State of Ohio Environmental Protection Agency

Re: 1061 Mill Park Drive / Fairfield County

This letter is written regarding the storm water inspection I conducted of the construction activities at the project located at 1061 Mill Park Drive, on September 10, 2010. I understand this site is currently covered under the General Storm Water Permit Associated with Construction Activities. Based on my site inspection and the conditions set forth in the General Permit, the following items must be addressed:

1061 Mill Park Drive
Stabilize barren areas
Maintain & install silt fence
Hocking River Watershed
September 10, 2010
Photo by: Greg Sanders

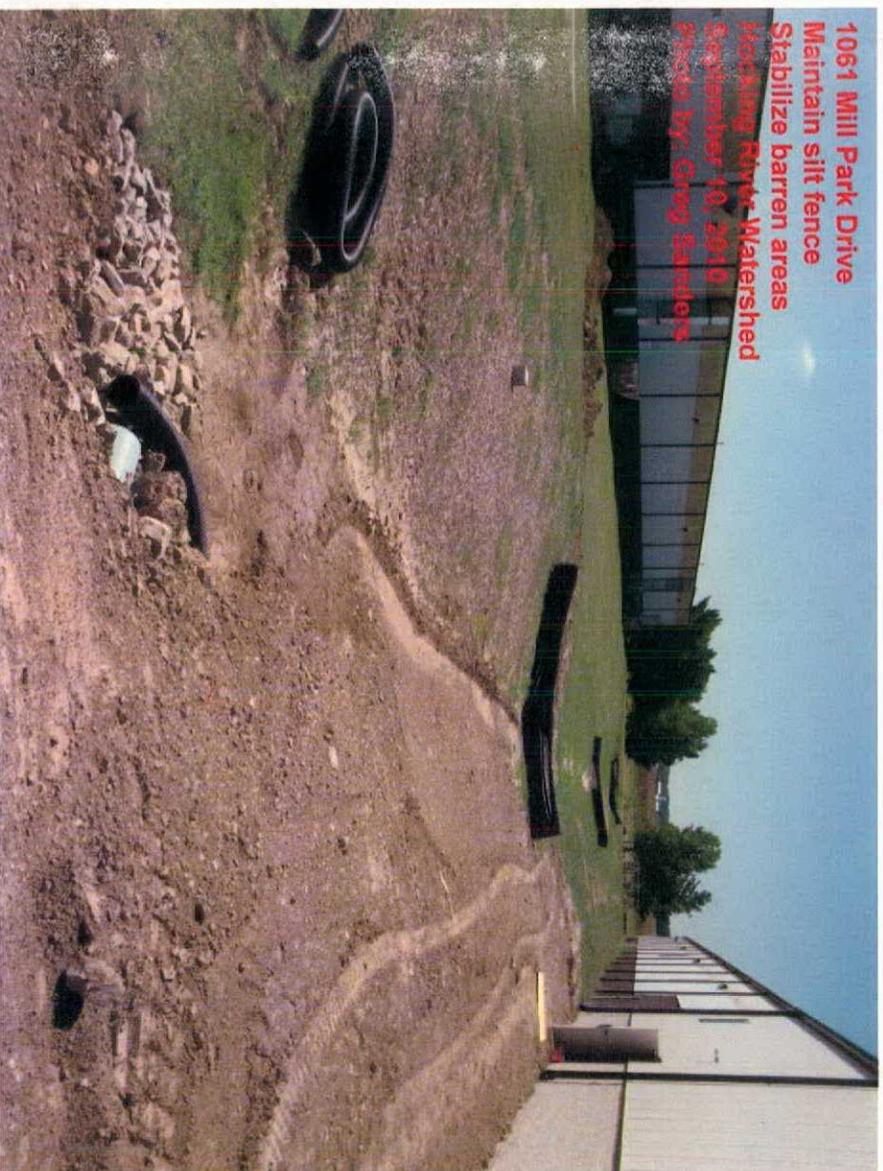
The project site had several large barren areas that appeared to be at final grade and were not stabilized. Please see attached pictures. Please be aware the General Permit mandates specific permanent and temporary stabilization requirements. All disturbed areas which remain idle in excess of 21 days must be protected from erosion within seven days of the last earth disturbing activities. All areas of final grade must be protected within seven days. All earth disturbing activities should be clearly logged in your inspection reports to ensure the 21 day / seven day requirement is not violated.

Silt fence appeared to be installed along Mill Park Drive but not along the sides of the building. Silt fence was not maintained along Mill Park Drive. Silt fence was being used as a check dam in the ditch, however, the silt fence was not installed in the ground to be effective. The General Permit requires the permittee to conduct inspections of all sediment and erosion controls every seven days or within 24 hours of a rain event equal to or greater than 0.5 inches. A log of the inspections and resulting corrective actions must be maintained on site available for review. All earth disturbing activities must be clearly documented in your inspection reports to ensure the temporary or permanent stabilization requirements are not violated. Please see attached pictures.

1061 Mill Park Drive
Maintain silt fence
Stabilize barren areas
Hocking River Watershed
September 10, 2010
Photo by: Greg Sanders

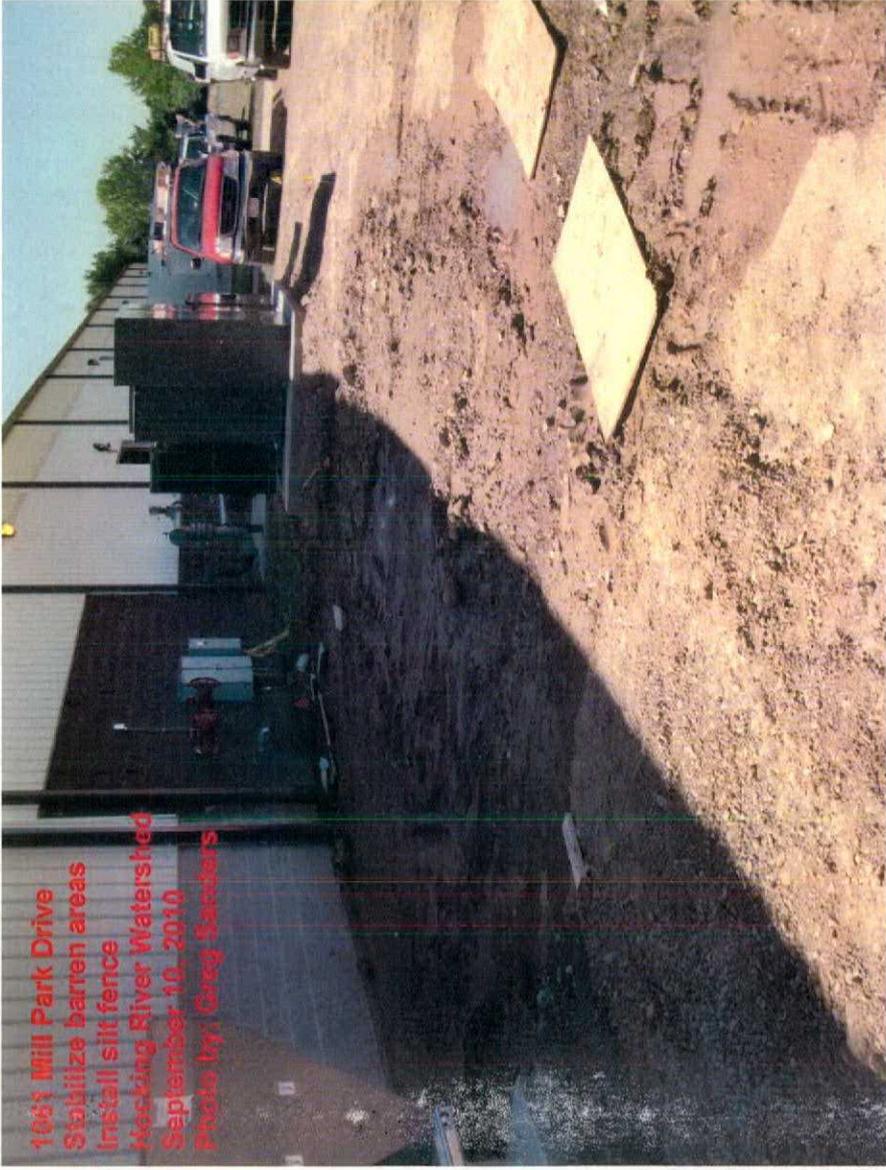
1051 Mill Park Drive
Stabilize barren areas
Install silt fence
Attocking River Watershed
September 10, 2010
Photo by: Greg Sanders
